Response to the Ofgem Consultation “North West Coast Connections – Consultation on the project’s initial Needs Case and Suitability for Tendering”

Friends of the Lake District Response to National Grid's North West Coast Connections (NWCC) Preliminary Environmental Impact Report.

The LDNPA LCT mapping (top) and National Grid's cropping of the LCTs at the National Park boundary

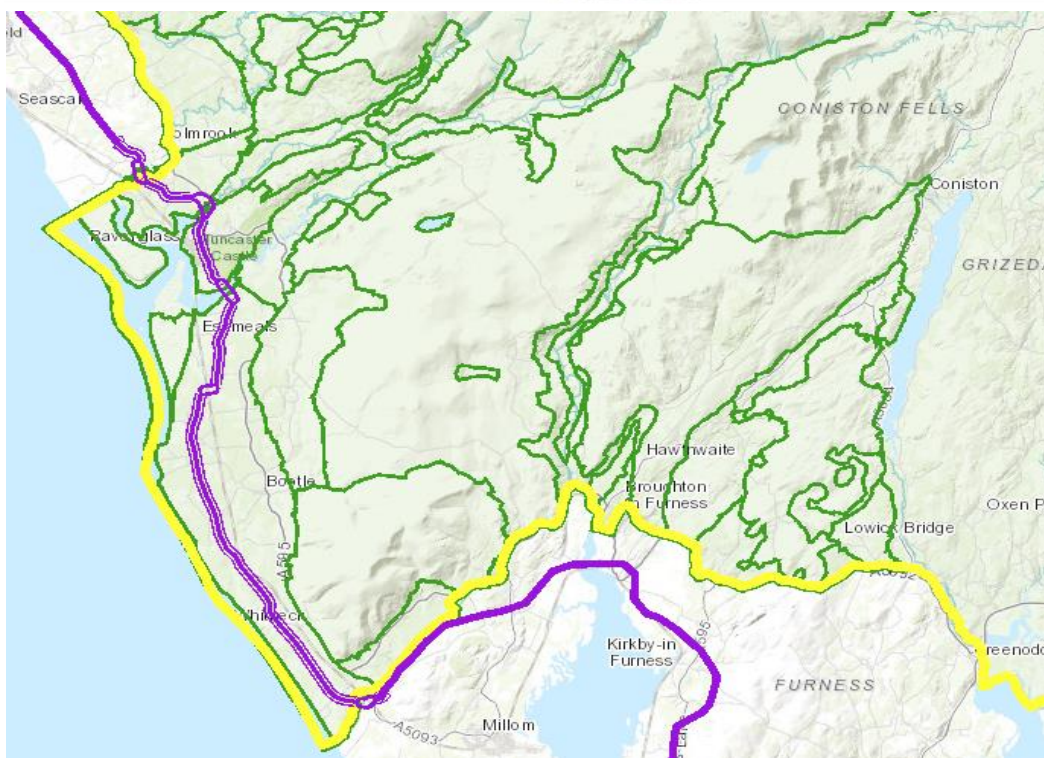
41. There are a number of places where Lake District National Park Landscape Character Types (LCT) cross the boundary of the National Park e.g. Type B, Type F and Type J. As shown on the maps below, these boundary-crossing LCTs have been systematically cropped at the boundary

on all the maps in National Grid's consultation which show LCTs. No explanation has been given for this omission of information. By National Grid.
